Agenda Item:           **Consideration – An Ordinance Approving Final Development Plans and a Final Plat of Subdivision for a ±60 Acre Warehouse/Distribution Development Known as Huntley Commercial Center (former Huntley Outlet Center)**

Petitioner/Owner:    **Huntley Investment Partners, LLC**

BUILDING ELEVATIONS & FINAL SIGNAGE PLAN  
CHI17-0051-00  
05.27.2021

## HUNTLEY, ILLINOIS LANDSCAPE DEVELOPMENT PLANS

**GRADING PLAN - SOUTHEAST**

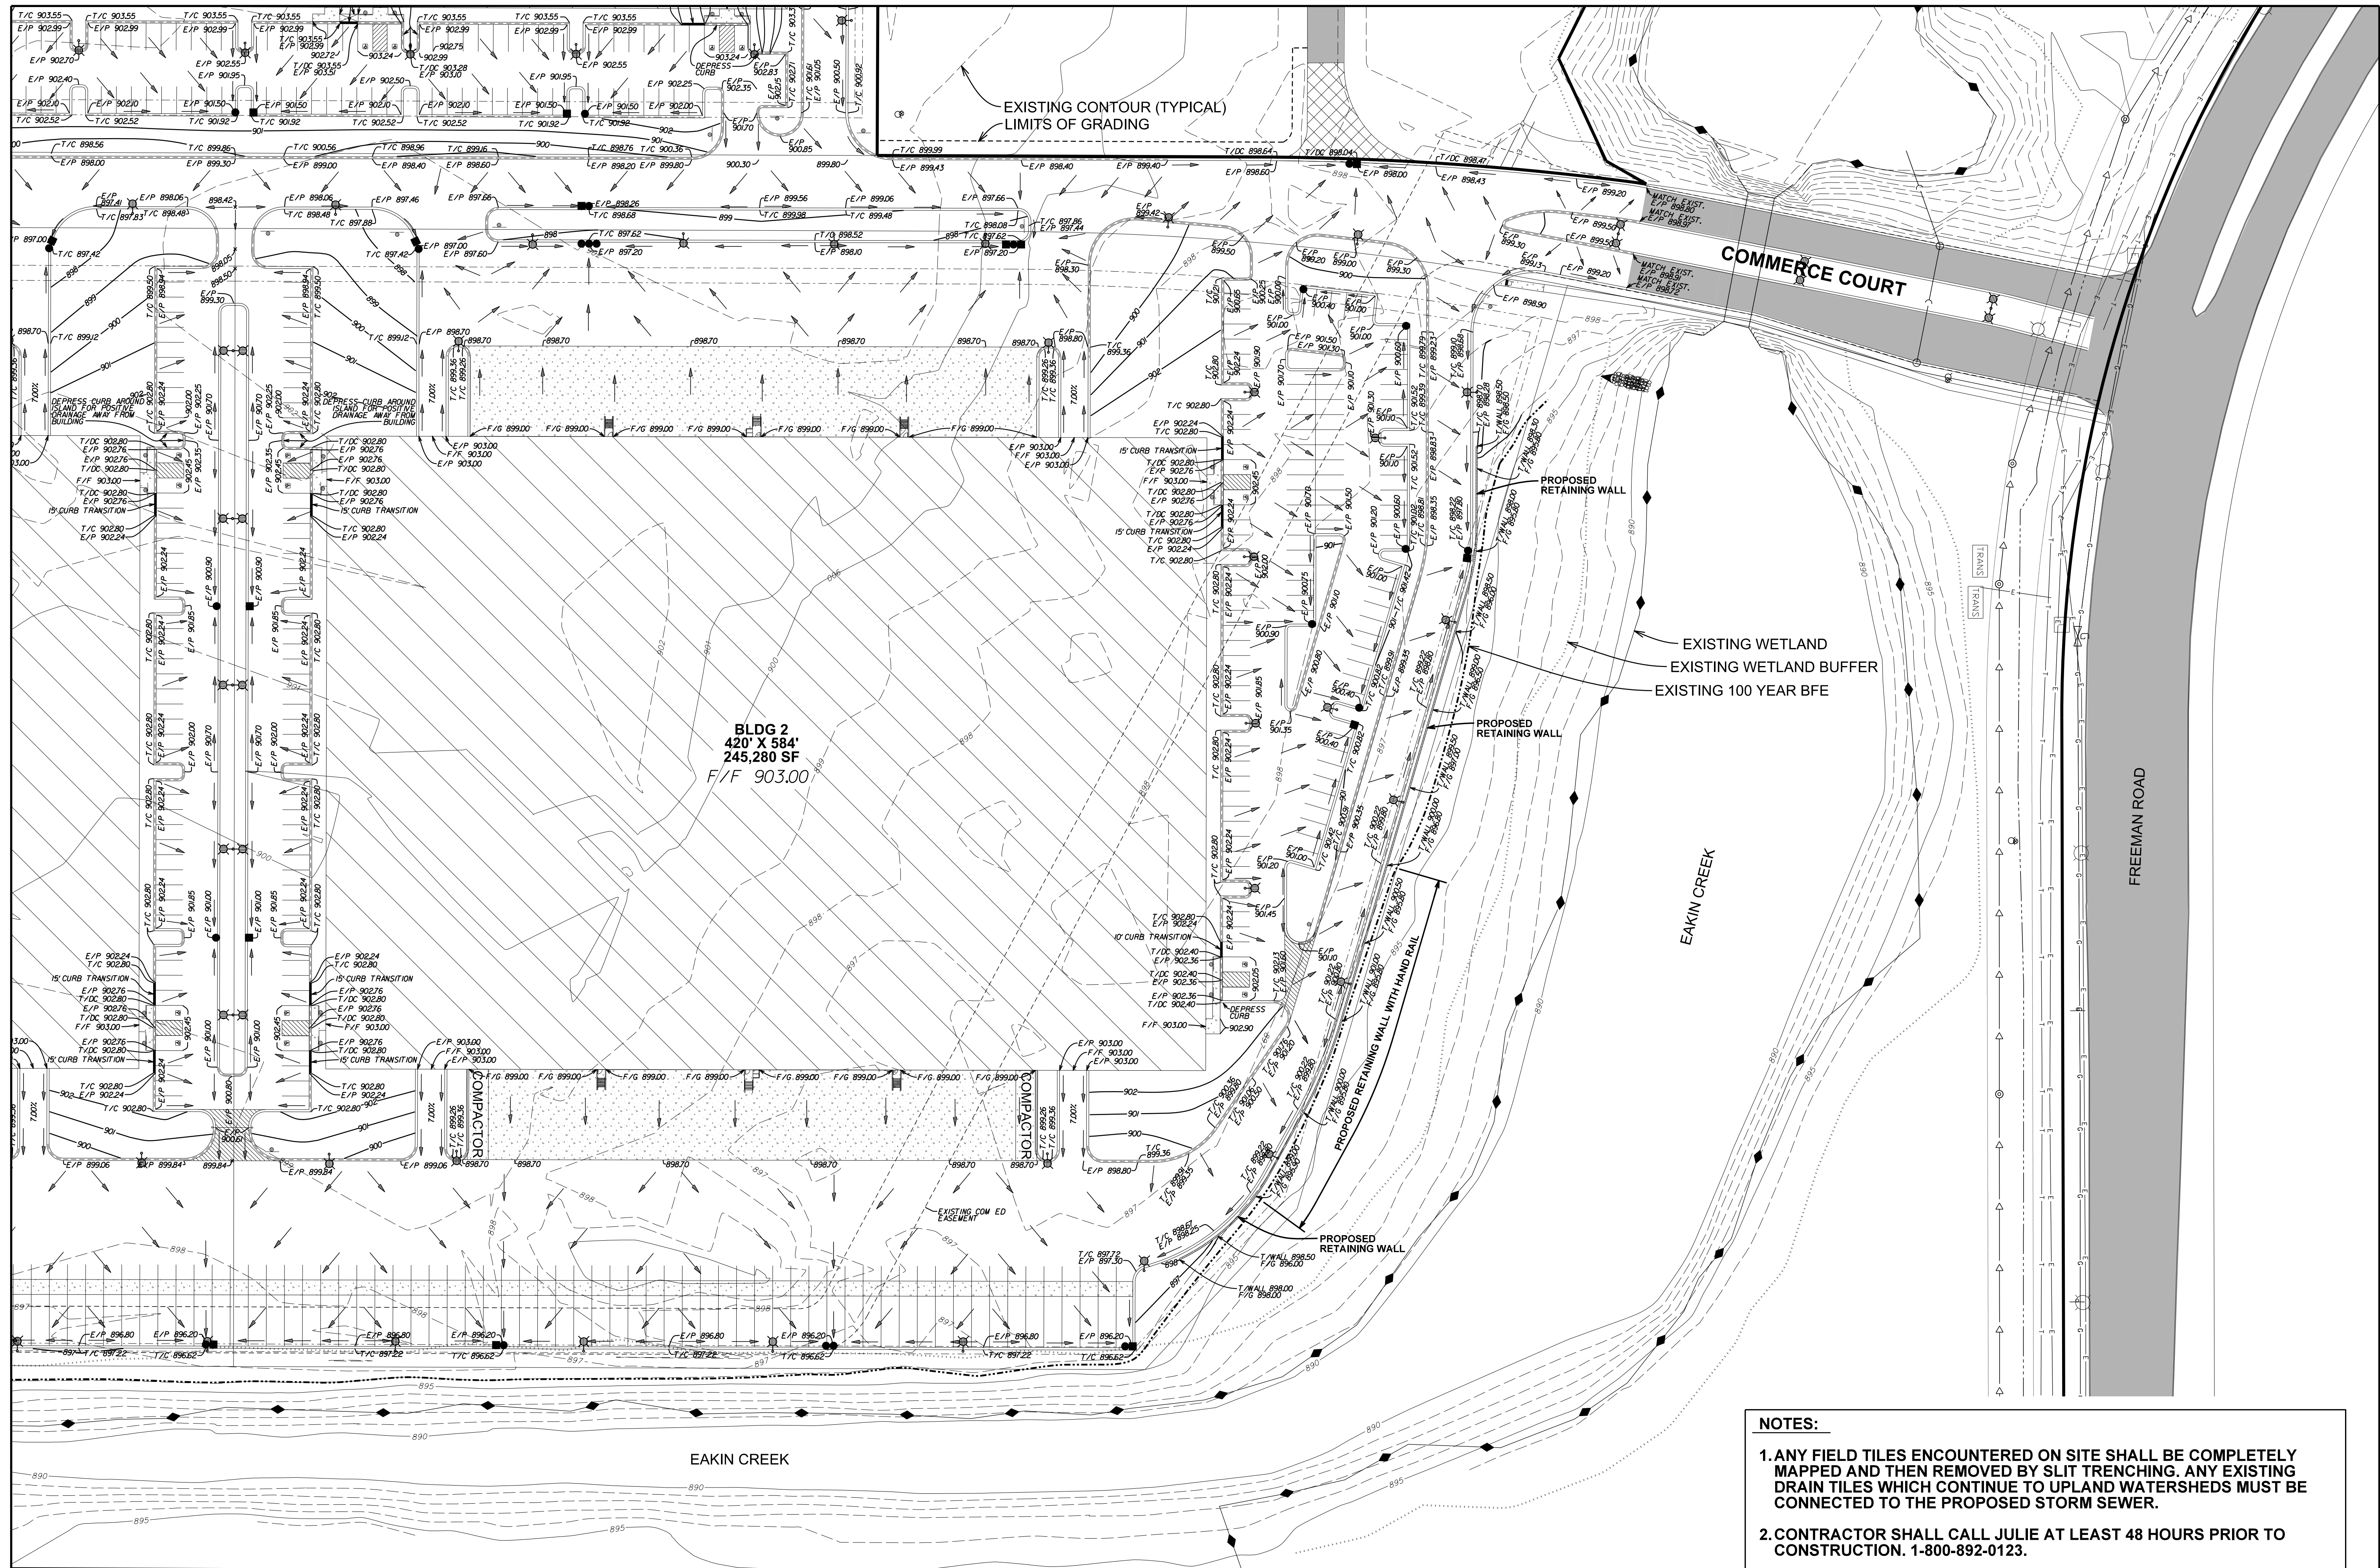
48. The proposed retaining wall along the south side of the parking area (adjacent to Interstate 90) shall be designed by a structural engineer licensed in Illinois. The final engineering plan submittal shall include sealed and signed structural calculations and structural plans.
49. Proposed contours shall be added to the turf areas surrounding the periphery of the proposed parking areas (typical to sheets 12 thru 14).

SHEET NUMBER  
**20**  
OF 26 SHEETS

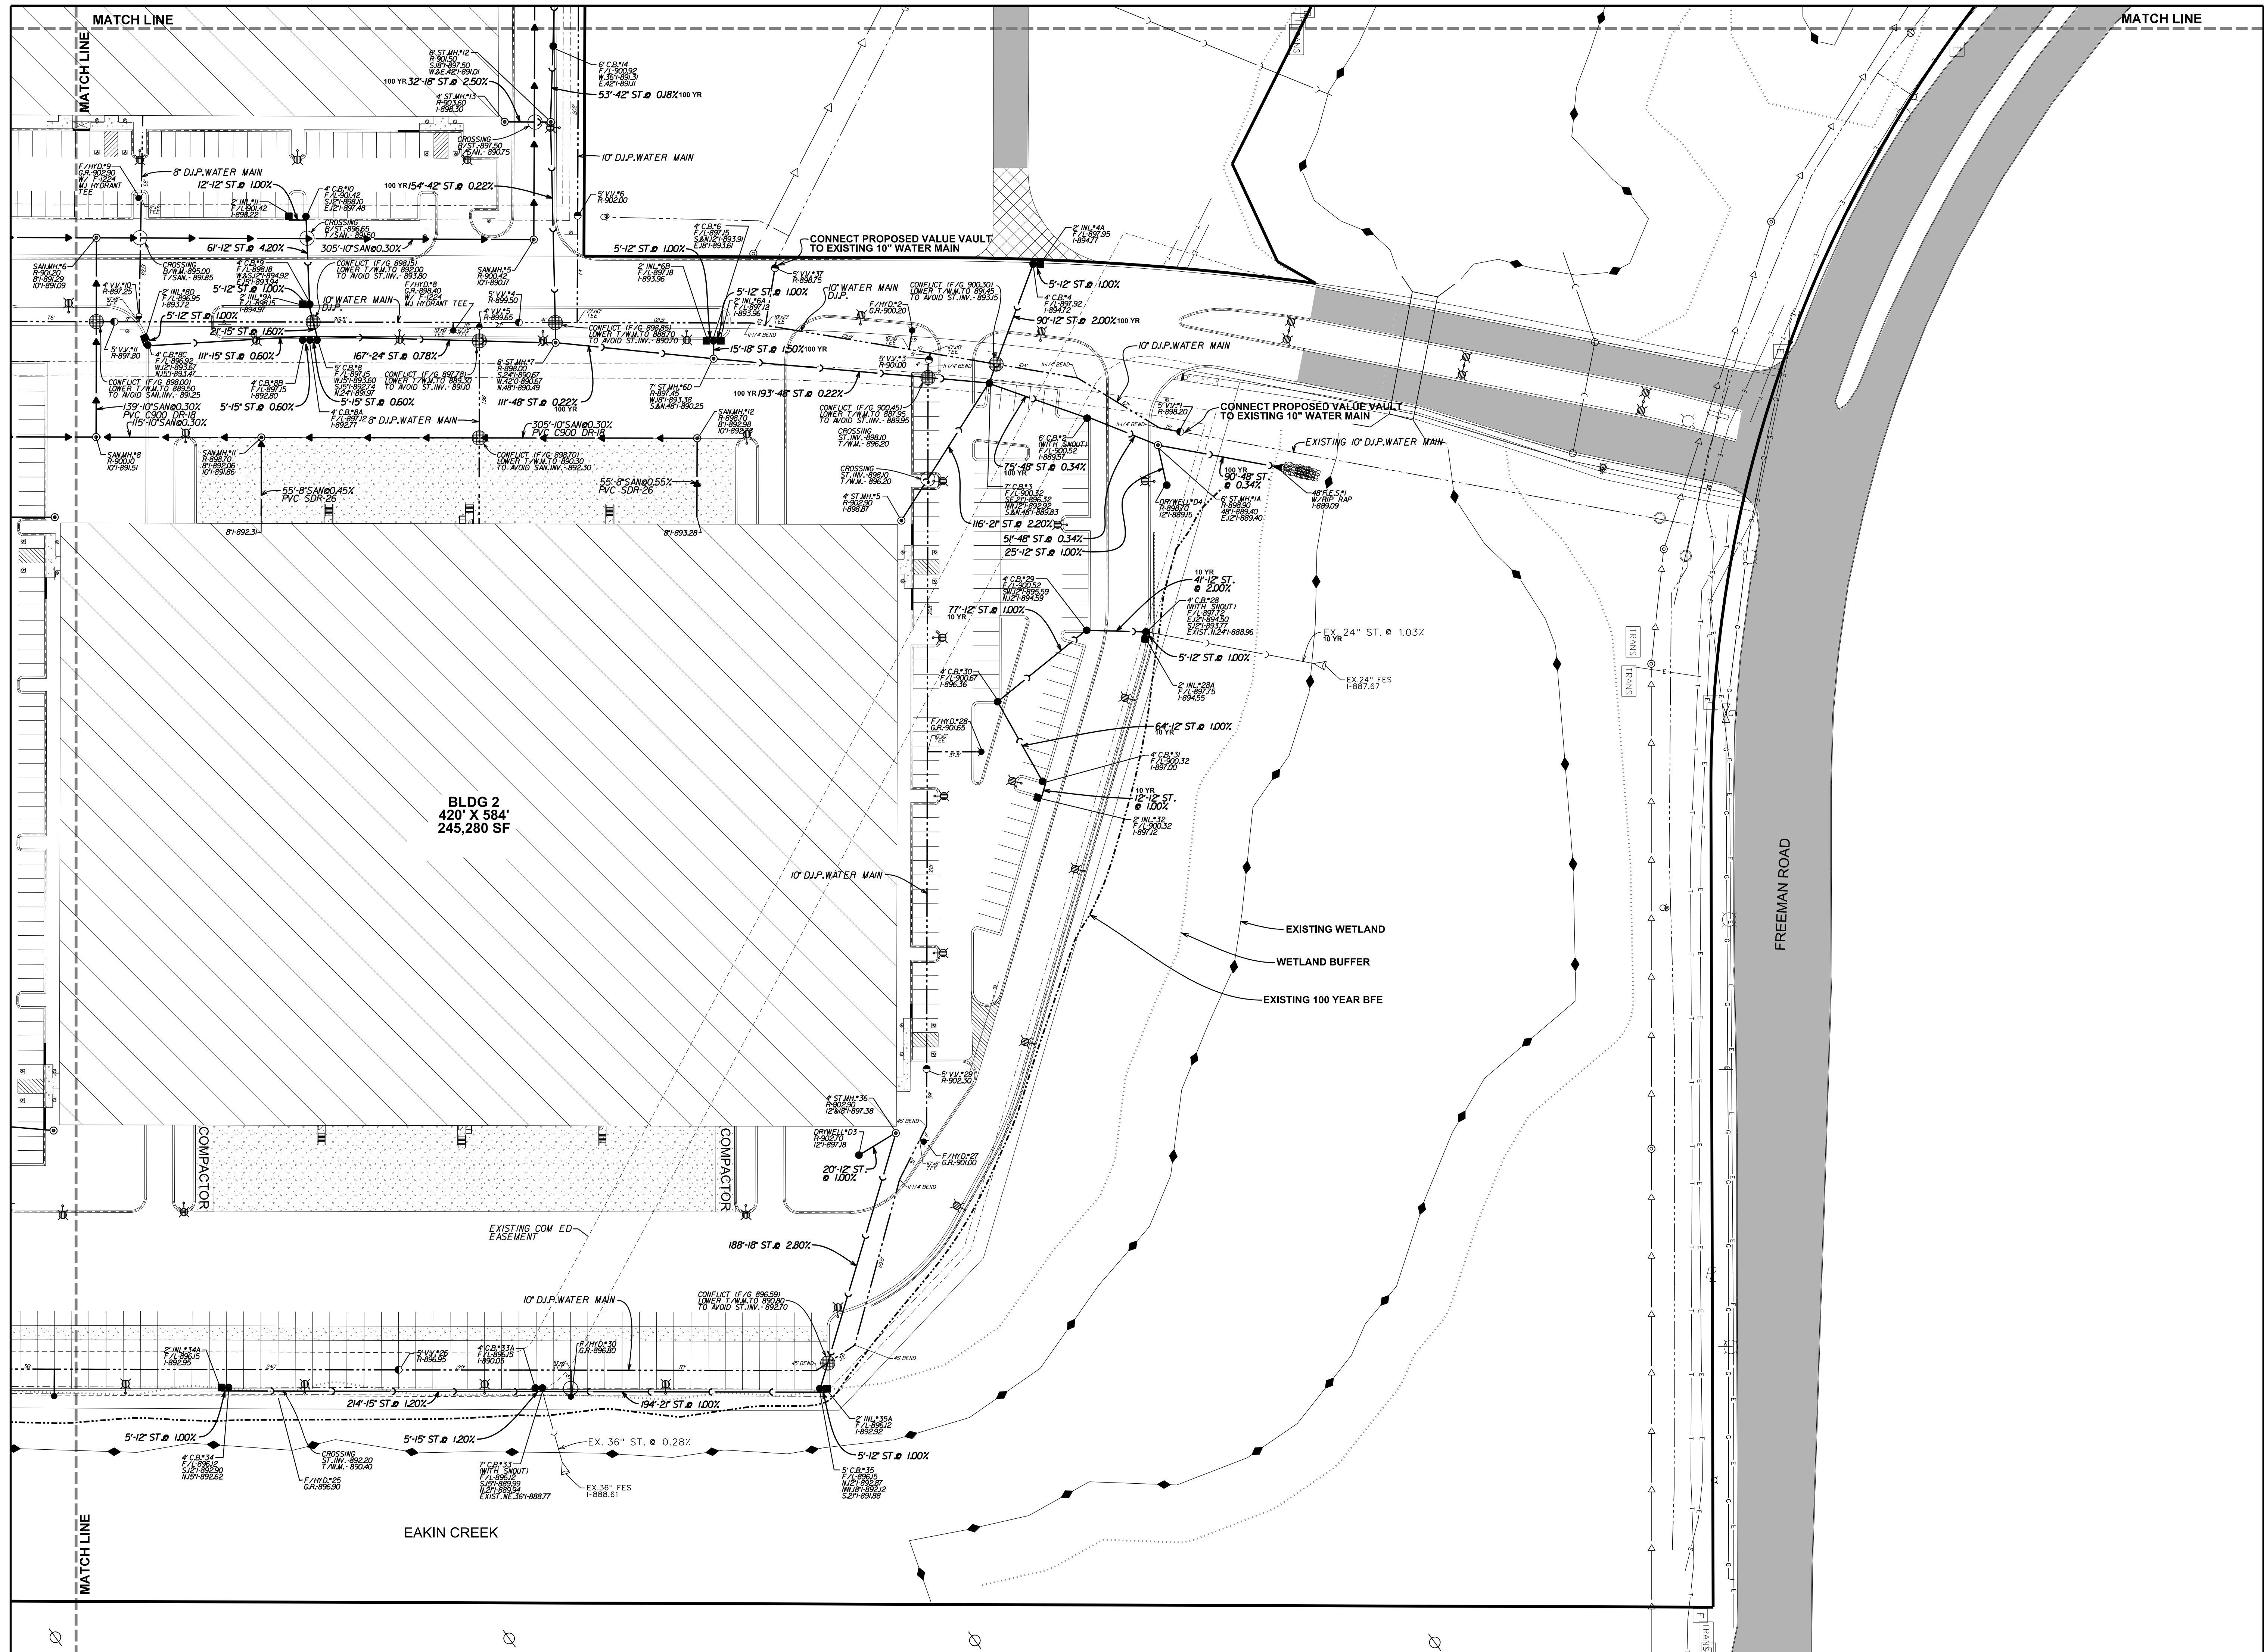
60. Individual lengths of all watermain shall be indicated on the plans. Individual lengths shall be provided between all valves, bends/fittings, hydrants. (Typical to sheets 20 thru 22)
61. The 8” valve in 4’ vault #15 shall be installed immediately east of the 10” water main and 10”x8” tee.
